CITY PLAN COMMISSION

FILE NUMBER: S223-243

REQUEST: An application to create one 1.537-acre lot from a tract of land in City Block A/6362 on property located on Buckner Boulevard, northeast of U.S. 175.

PRELIMINARY PLAT
212 BUCKNER BLVD ADDITION
LOT 1, BLOCK A/6362
 A Portion of City Block 6362
 Being 1,537 Acres in the
 South Perry Addition, Block 11564
 City of Dallas, Dallas County, Texas

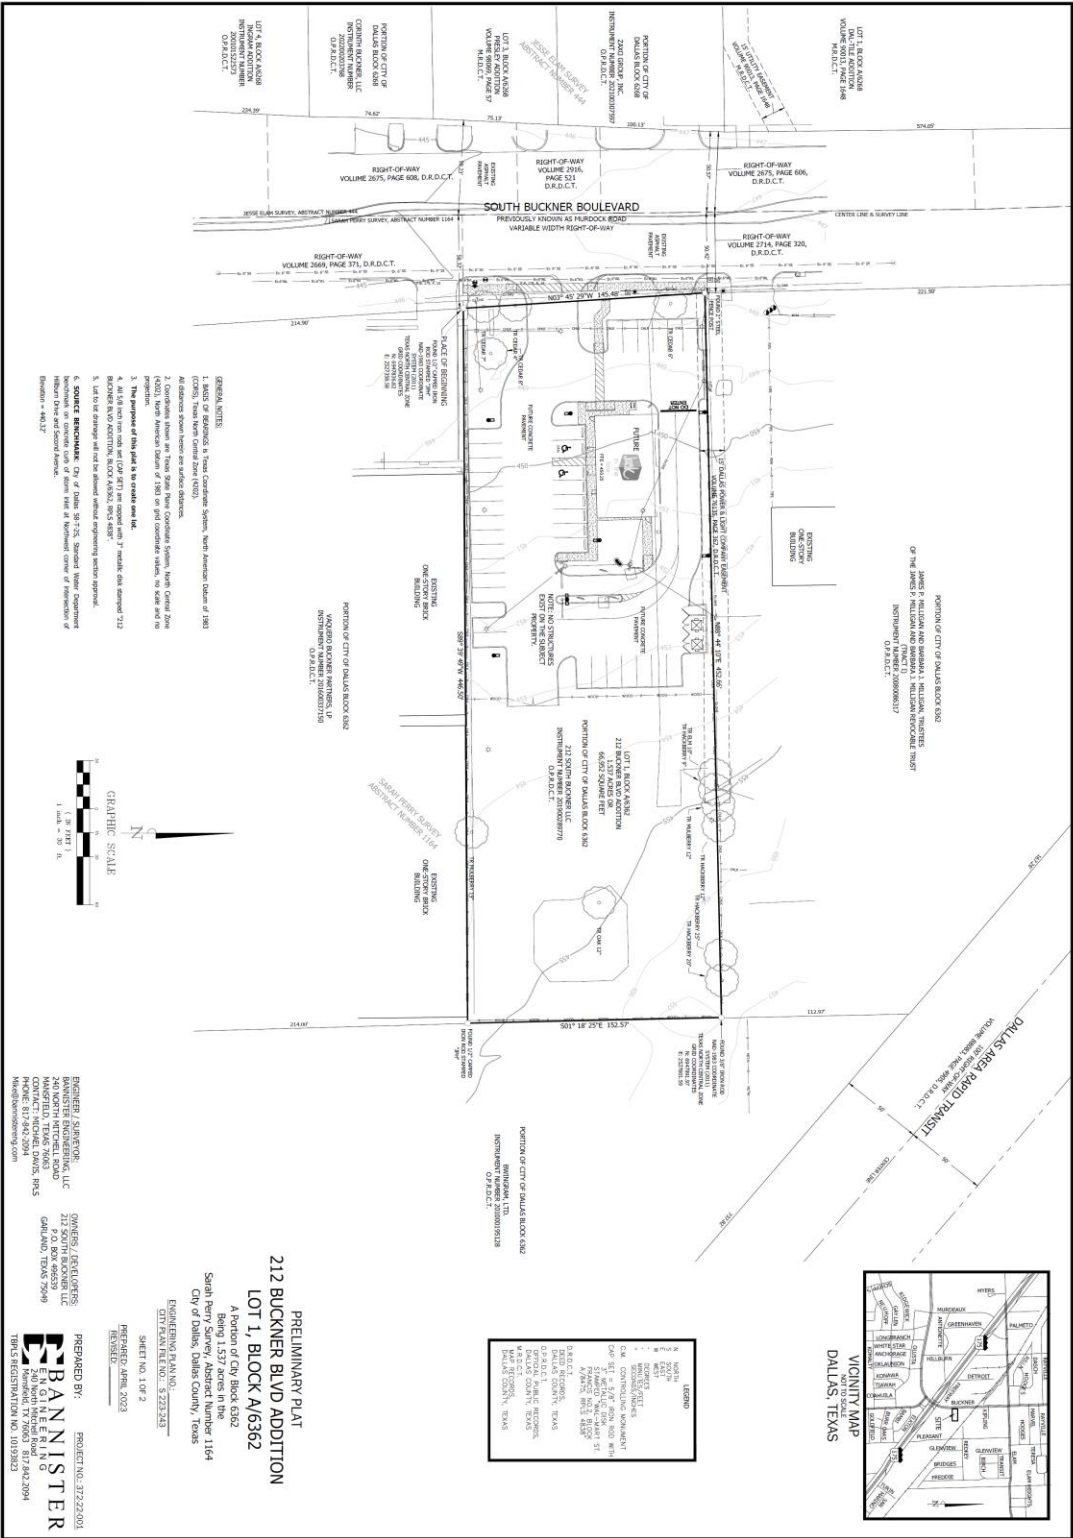
7. On the final plat, include two boundary corners tagged with these coordinates: "Texas State Plane Coordinate System, North Central Zone, North American Datum of 1983 on Grid Coordinate values, No Scale and no Projection."

8. On the final plat, monument all set corners per the Monumentation Ordinance. Prior to submittal of the final plat for the Chairman's signature. The monuments must be verified by the Chief City Surveyors Office in the Public Works Department. *Section 51A-8.617*
9. Provide ALL supporting documentation (i.e. deeds, plats, ordinances, easements...etc.) with a completed Final Plat Checklist to the Survey Plat Review Group (**SPRG**) with the Final Plat Submittal **after** City Plan Commission Approval.
10. Prior to the final plat, submit a tree survey to the Arborist. A release from the arborist is required prior to an early release request or the recordation of the plat, whichever occurs first.
11. The number of lots permitted by this plat is one.

15. On the final plat, dedicate 53.5 feet of right-of-way (via fee simple) from the established center line of Buckner Boulevard. Section 51A 8.602(c).
16. TxDOT approval may be required for any driveway modifications or new access.

17. Prior to final plat, submit a completed final plat checklist and all supporting documents.
18. On the final plat, show recording information on all existing easements within 150 feet of the property.
19. On the final plat, show all additions or tracts of land within 150 feet of property with recording information.
20. On the final plat, need new/different plat name. Addition name can not begin with a number.

22. On the final plat, change “South Buckner Boulevard” to “Buckner Boulevard”.
23. On the final plat, identify the property as Lot 1 in City Block A/6362. Ordinance 1A, Page 131 pages 131-148, Section 2 (passed August 13, 1872).
